To: T10 Technical Committee
From: Amr Wassal, PMC-Sierra (amr_wassal@pmc-sierra.com)
Date: 7 September 2006
Subject: 06-324r2 SAS-2 Modifications to the SAS Speed Negotiation

Suggested changes to chapter 6 (Phy Layer)

Figure 123 — SAS SNW-3 speed negotiation window

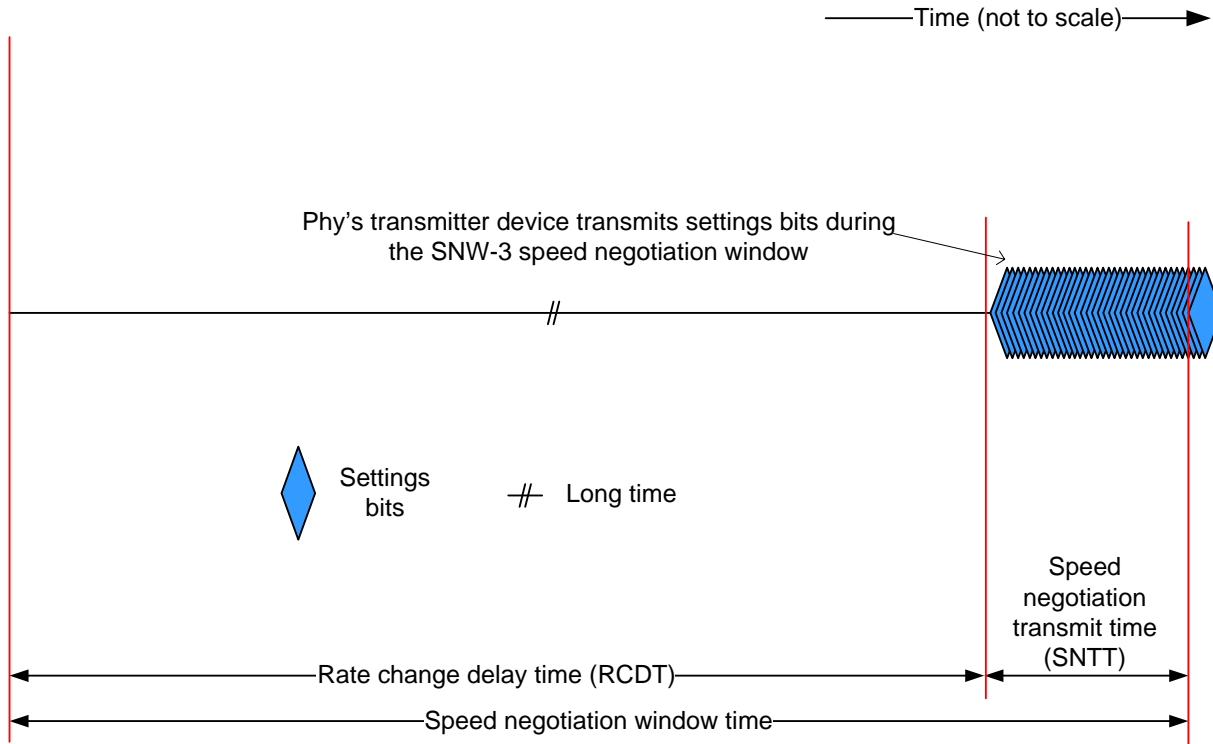
Figure 123 defines the SAS SNW-3 speed negotiation window, including:

- a) speed negotiation window time;
- b) speed negotiation window rate of 1,5 Gbps;

- c) rate change delay time (RCDT); and
- d) speed negotiation transmit time (SNTT)..

Figure 124 — SAS SNW-Final speed negotiation window

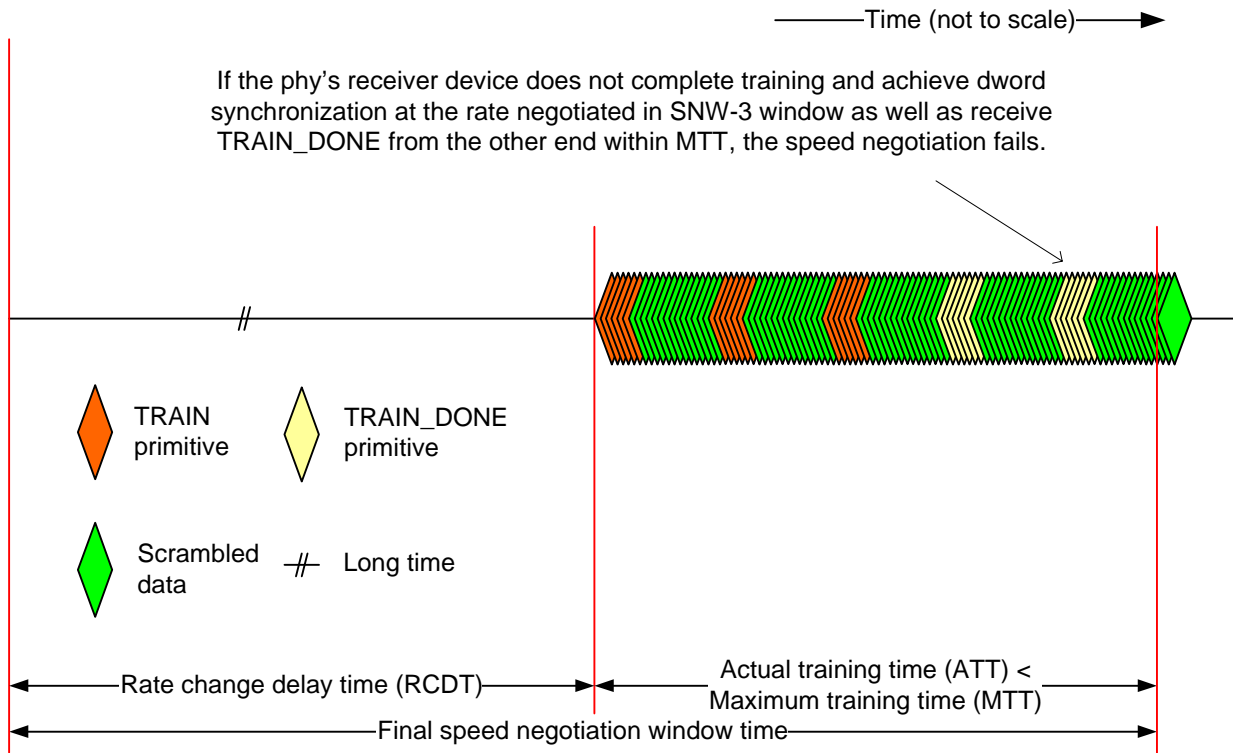
Figure 124 defines the SNW-Final speed negotiation window, including:

- a) Maximum final speed negotiation window time;
- b) rate change delay time (RCDT); and
- c) maximum training time (MTT).

The training pattern consists of repeating pattern segments. Each pattern segment shall start with a redundant primitive sequence of TRAIN primitives followed by 232 bytes 00h that are transmitted scrambled and 8b10b encoded. The scrambler is identical to that of the link layer and shall be re-initialized at the beginning of the TRAIN sequence of the first segment only. When the phy's receiver device is trained and has acquired dword synchronization, the phy shall replace the TRAIN primitive sequences in the pattern segments with TRAIN_DONE primitive sequences. A minimum of 4 segments must be transmitted with TRAIN_DONE primitive sequence before a Phy Layer Ready confirmation is sent to the link layer.

Figure 125 — SAS speed negotiation sequence (phy A: G1, G2, G3, phy B: G2 only)

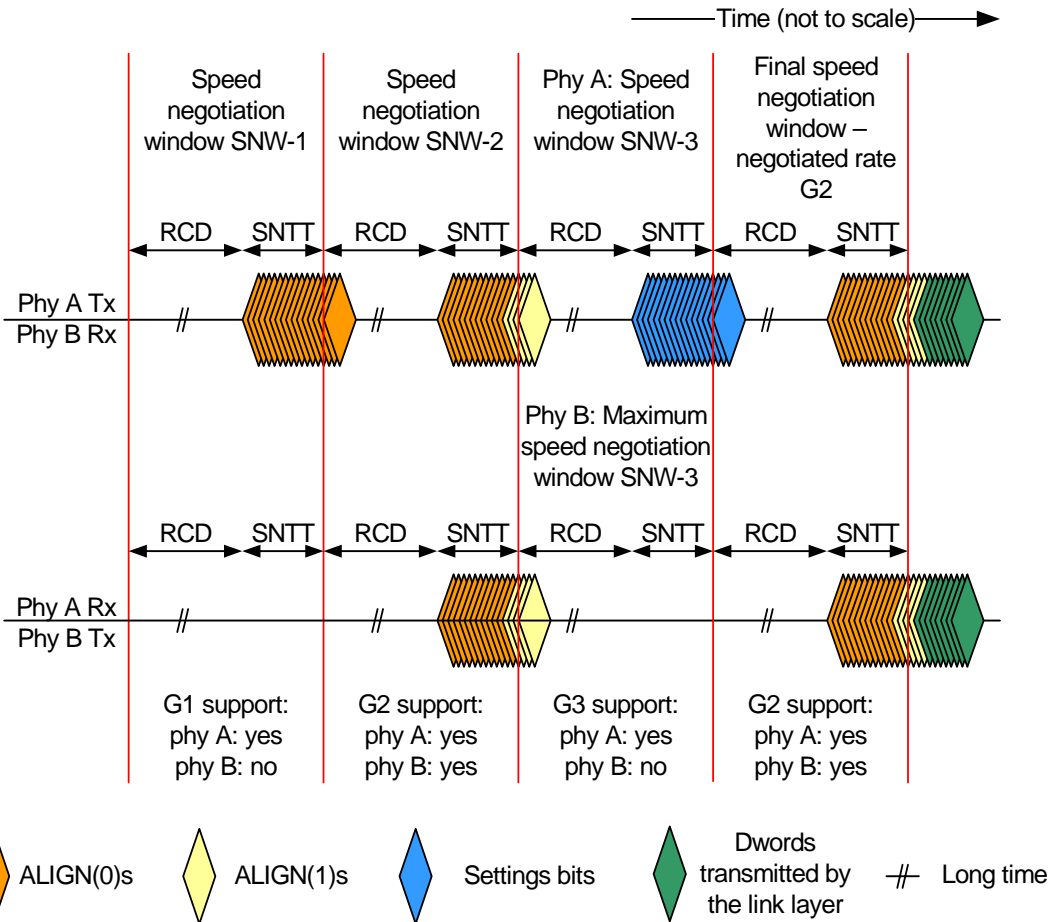
Figure 125 shows speed negotiation between a phy A that supports G1 through G3 and a phy B that only supports G2. Both phys run:

- 1) the SNW-1 speed negotiation window, supported by phy A but not by phy B;
- 2) the SNW-2 speed negotiation window, supported by both phys; and
- 3) the SNW-3 speed negotiation window, supported by phy A but not by phy B.

Phy A reaches its limit because it has run a speed negotiation window that does not detect a valid physical link rate (i.e., SNW-3) after having detected a valid physical link rate in a previous speed negotiation window (i.e., G2 in SNW-2). Phy B reaches its limit because it has reached the speed negotiation window corresponding to its highest support physical link rate plus one (i.e., SNW-3). Both phys select G2 for the SNW-Final speed negotiation window to establish the negotiated physical link rate.

Figure 127 — SAS speed negotiation sequence (phy A: G1, G2, G3 or higher, phy B: G1, G2, G3 or higher)

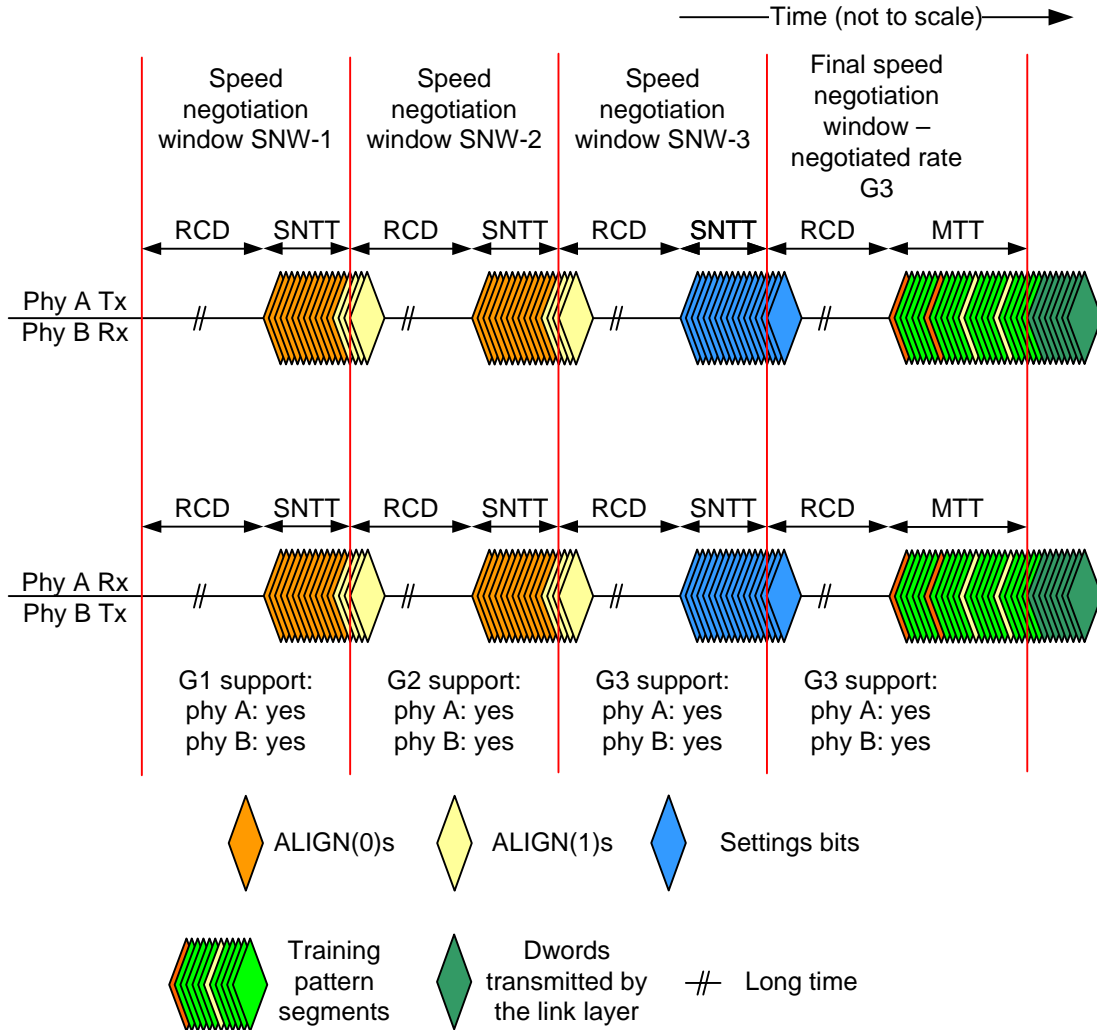
Figure 127 show speed negotiation between a phy A and a phy B that both support G3 rate or higher. Both phys run:

- 1) the SNW-1 speed negotiation window, supported by both phys;
- 2) the SNW-2 speed negotiation window, supported by both phys; and
- 3) the SNW-3 speed negotiation window, supported by both phys where the settings bits are exchanged and the highest common rate supported by both phys is negotiated; and

4) the SNW-Final speed negotiation window, supported by both phys where training is done.

Figure 128 — SAS speed negotiation sequence - SNW-3 (maximum SNW) phy reset problem

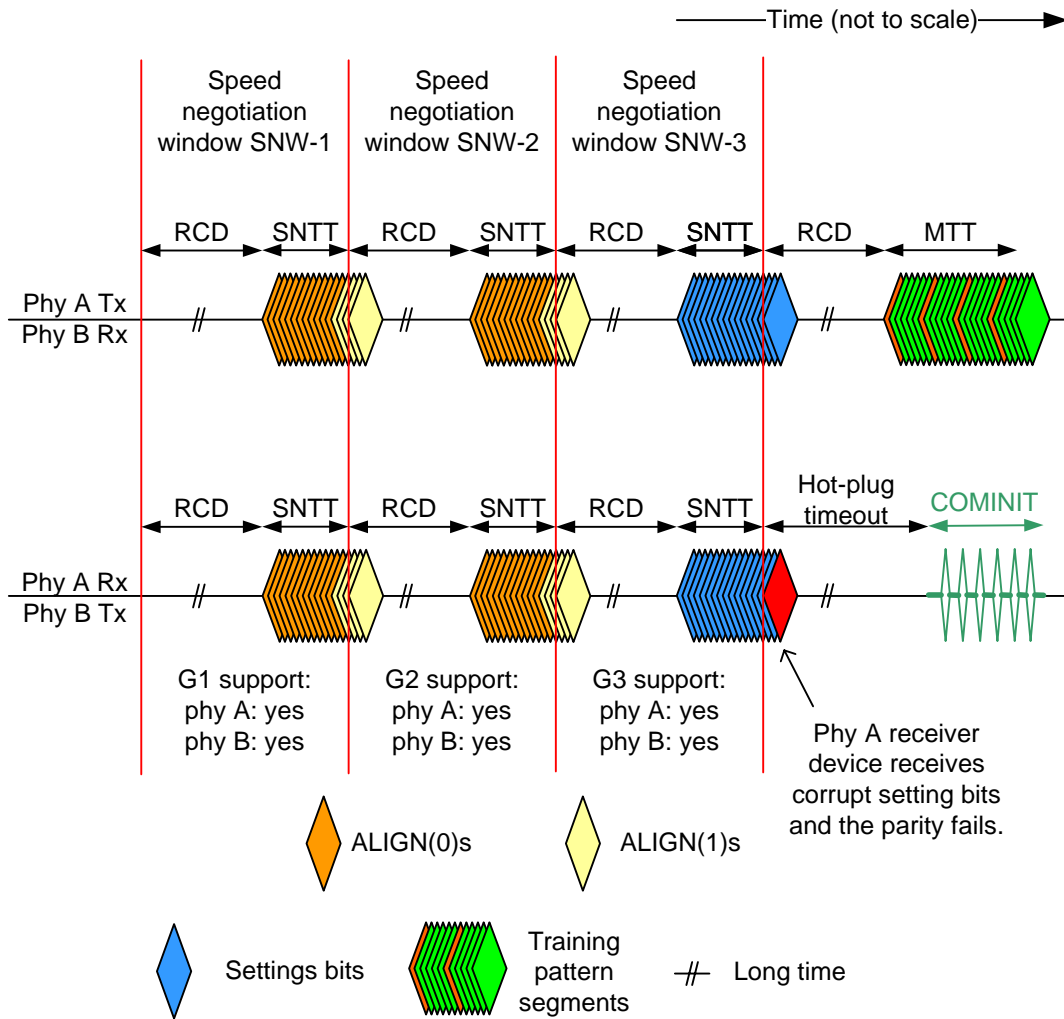
- 1) the phys do not exchange the settings bits properly (e.g., due to a parity error) in SNW-3 window (see Figure 128); or

Figure 129 — SAS speed negotiation sequence - training (SNW-Final) phy reset problem

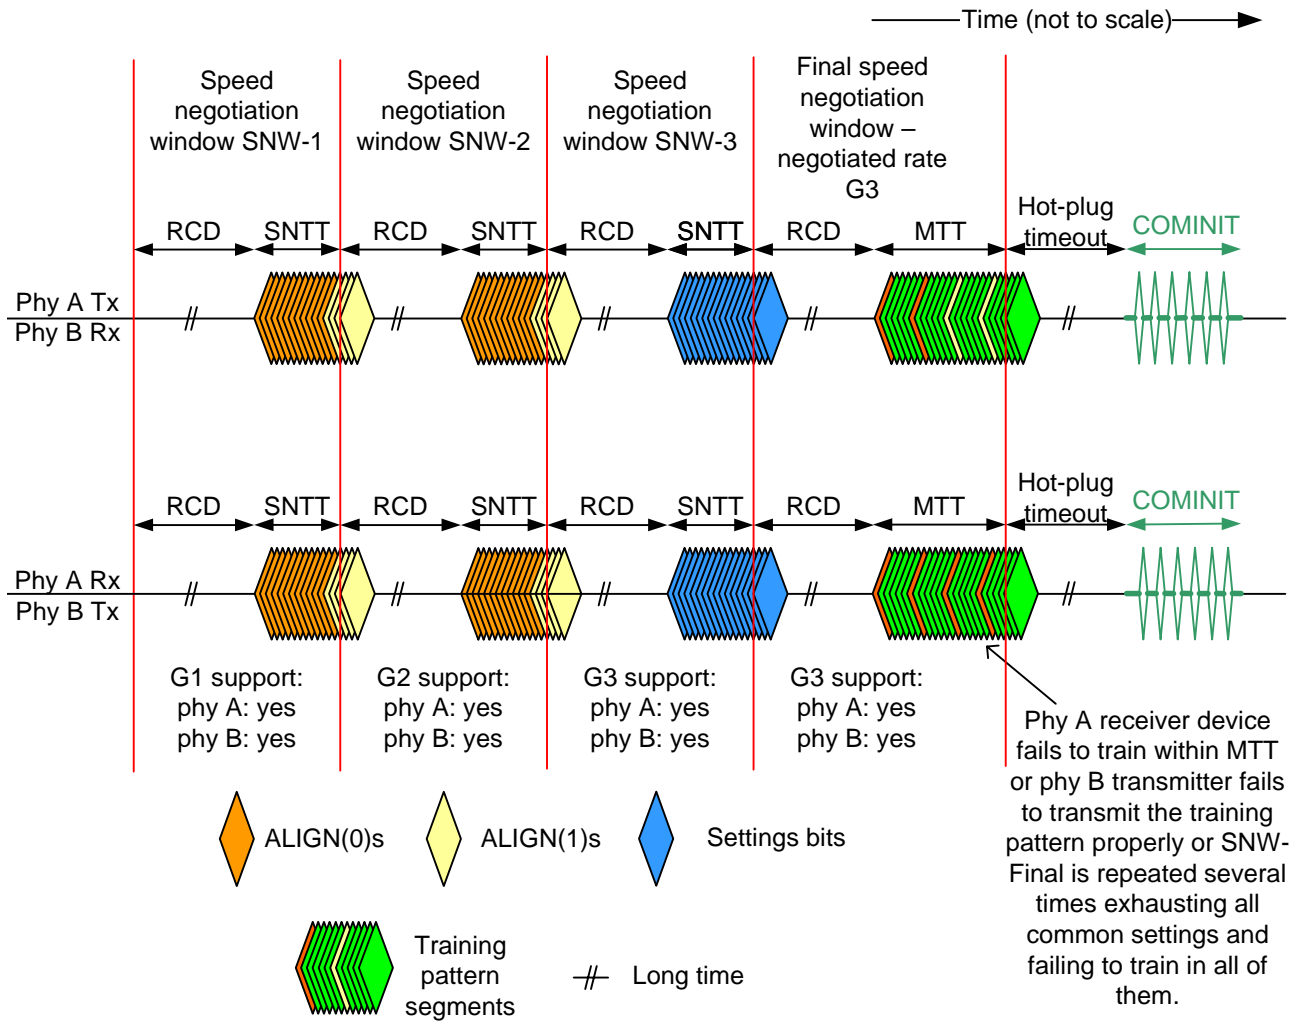
- 2) either phy does not complete training within the MTT interval of several training windows exhausting all common settings exchanged in SNW-3 (see Figure 129)..

Figure 132 — SP (phy layer) state machine - SAS speed negotiation states (continued)

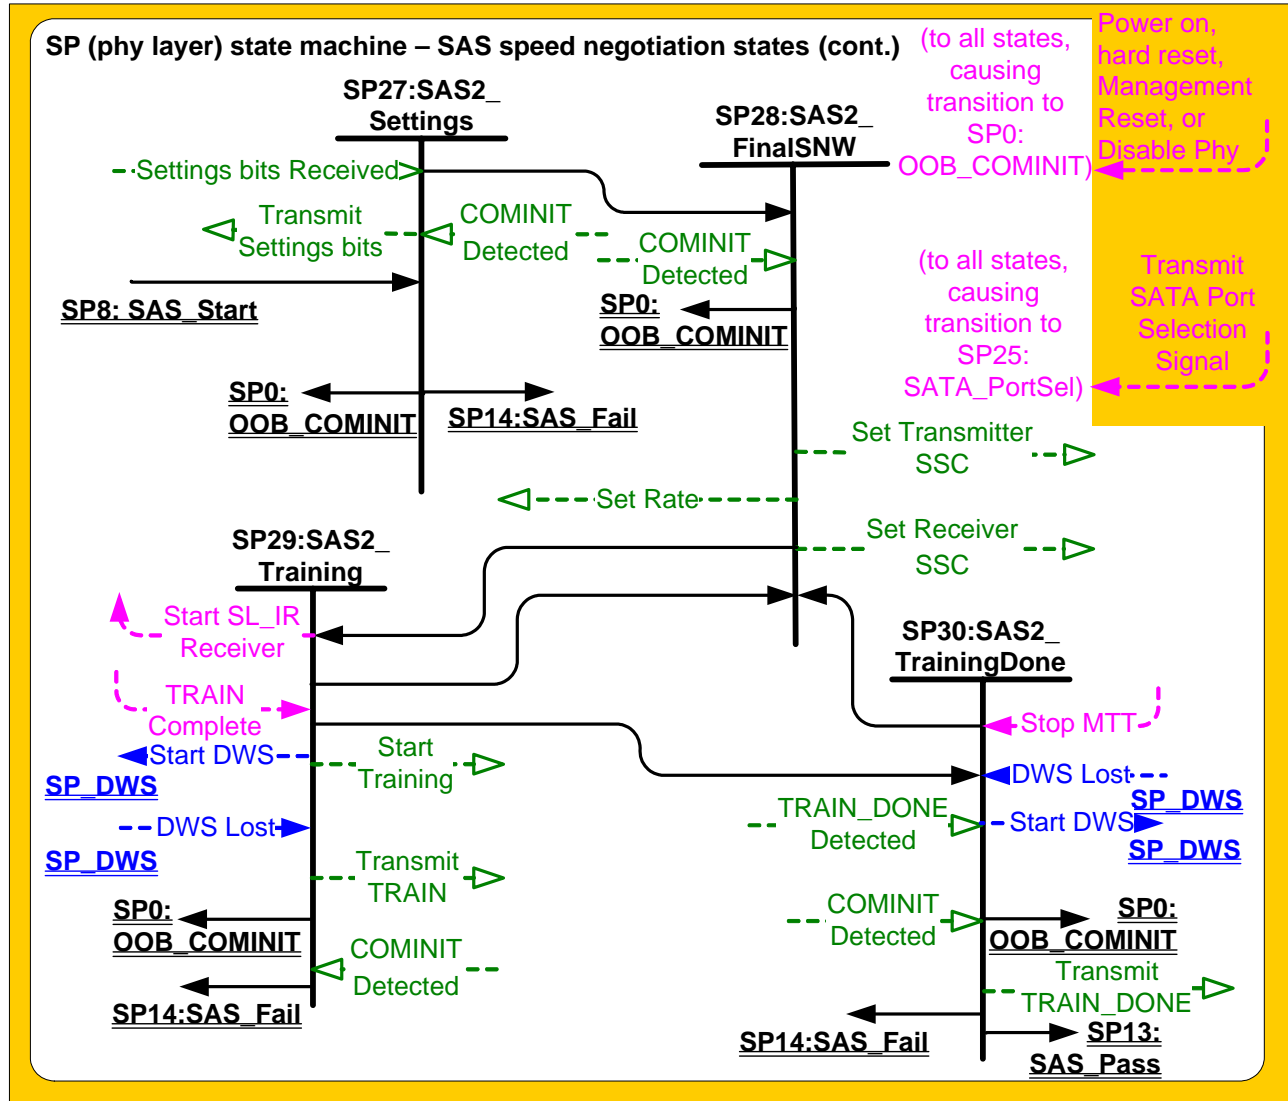
Figure 132 shows the rest of the SAS speed negotiation states related to SNW-3 and the SNW-Final speed negotiation windows. These states are indicated by state names with a prefix of SAS2.
